Access Compliance Report

Public Rights-of-Way

(Curb Ramps)

Intersection ID: 50316	Main Street: ESMERALDA_DR	Cross Street: STATESVILLE_RD	Location: NW
ADA ID: D4EFD4F1AD7C	Ramp Type: Para	Initial Pass/Fail: Fail	Overall Compliance: No
Severity Score: 13.75			
Codes/Mitigation Info/Possible Solution		Field Measurements/Component Compliance

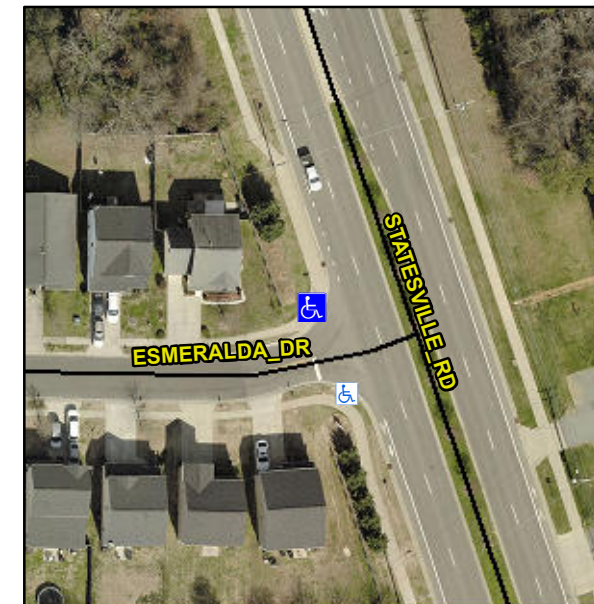
Surveyor Notes:

LT RP < 5%

PROW/ADA:

R304.3.2, R304.5.3

Possible Solutions:

Remove & Replace Entire Ramp.
